IMP7561-1.1

ACOUSTIC REVIEW OF VENTA ACOUSTICS REPORT

Report Ref: VA4834.230809.NIA

200 Sea Front

1.4 Equipment

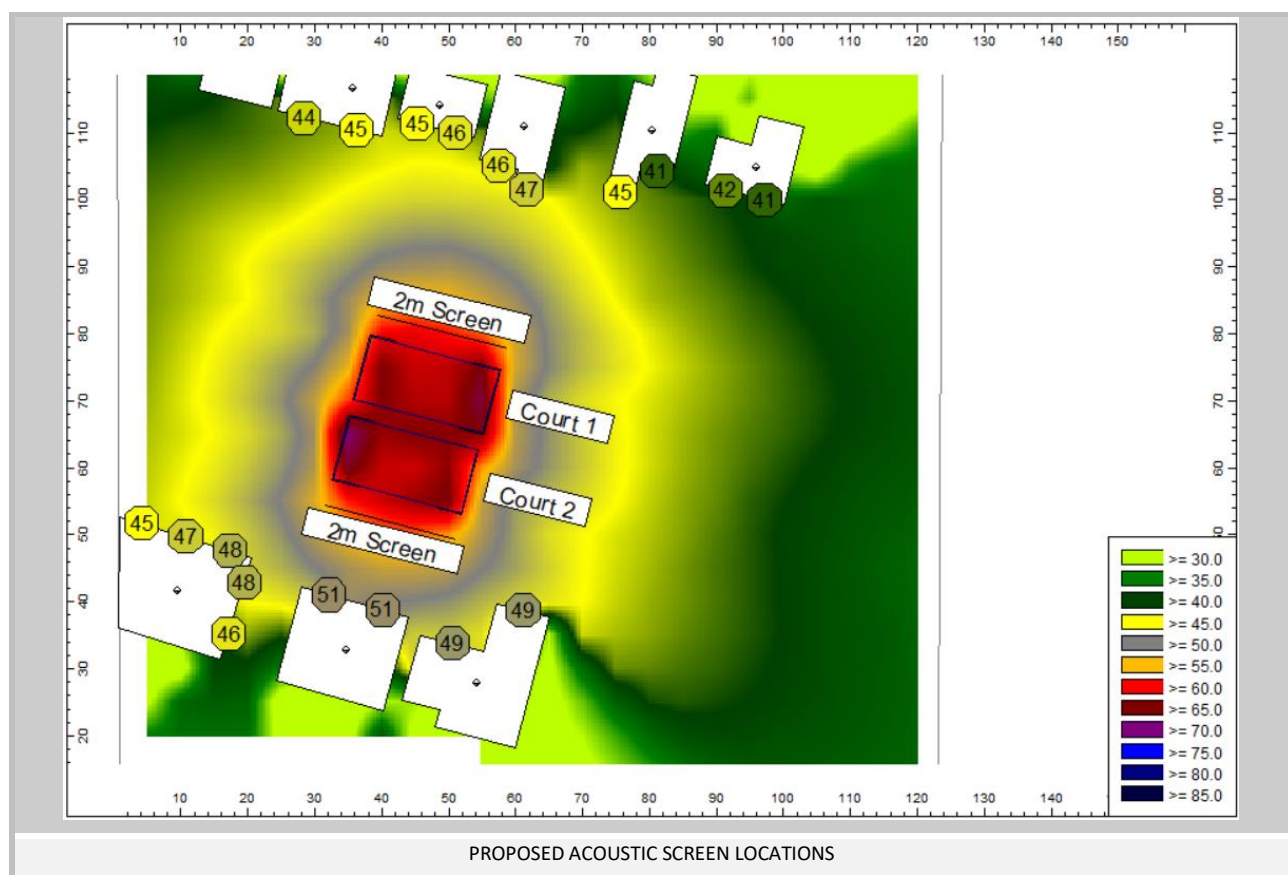
The equipment used within the Venta Acoustics assessment is compliant and up to date with the calibration requirements. The equipment's accuracy was verified before and after the assessment and no discrepancies identified.
